REFERENCE:	TSB: 08-026-25 REV. B GROUP: 08 - Electrical	Date:	April 29, 2025	REVISION:	08-026-25 REV. A
VEHICLES AFFECTED:	2024 (LB) Dodge Charger This bulletin applies to vehicles equipped with 400V G2500 FR/RR Elec Drive Motors (Sales Code ELD).			MARKET APPLICABILITY: ☒ NA☒ MEA ☒ SA☒ IAP ☒ EE☒ CH	
CUSTOMER SYMPTOM:	Customers may experience a Malfunction Indicator Lamp (MIL) illumination and the vehicle may exhibit/set one or more of the following Diagnostic Trouble Codes (DTCs): ● C10F8-00 - Left Front Wheel Hub Disconnect Actuator Position Sensor Circuit Range/Performance. ● C10F9-00 - Right Front Wheel Hub Disconnect Actuator Position Sensor Circuit Range/Performance. ● P061B-00 - Internal Control Module Torque Calculation Performance. Customers may also comment on one or more of the following: ● **Instrument Panel Cluster (IPC), radio range and charge time estimations and messages are not correct. ● Battery range incorrect. ● Improved battery State of Charge (SoC) accuracy in off-nominal conditions. ● Battery heating values incorrect on radio when on Performance Pages display. ● Charging does not start when plugged in. ● Charging is not indicating when battery is at full char

Fig. 1
Cooling Fan Assembly

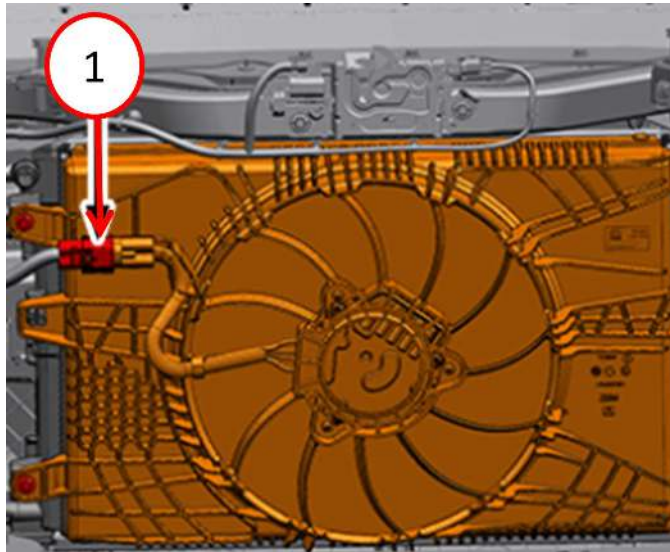
4. Disconnect the cooling fan wire harness connector [Fig. 1](#).

1 - Wire Harness To Disconnect/Connect

24. **Install the #38 AGSM fuse [Fig. 3](#) and the PDC cover [Fig. 2](#).
25. Position the rear carpet in place.**
26. Connect the cooling fan wire harness connector [Fig. 1](#).
27. Install the front storage bin. Refer to the detailed service procedures available in DealerCONNECT/ ServiceLibrary under: Service Info> 23 - Body / Exterior / Bin, Storage / Installation.
28. Clear any DTCs that may have been set in any modules due to reprogramming. The wiTECH application will automatically present all DTCs after the flash and allow them to be cleared.

Fig. 3
#38 AGSM Fuse Location

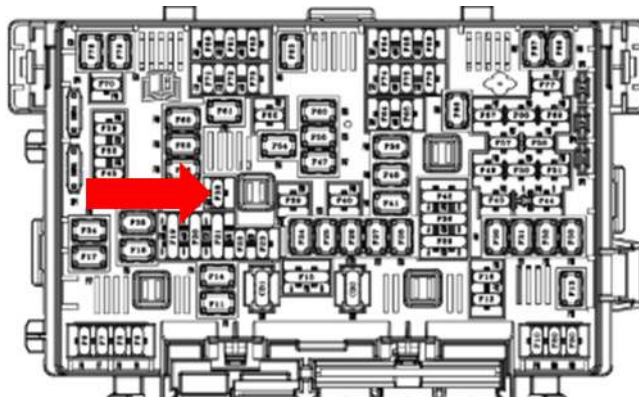
Failure to remove the #38 AGSM fuse will result in damage to the shifter.

6. Remove the PDC cover, locate and remove the #38 AGSM fuse [Fig. 3](#).**
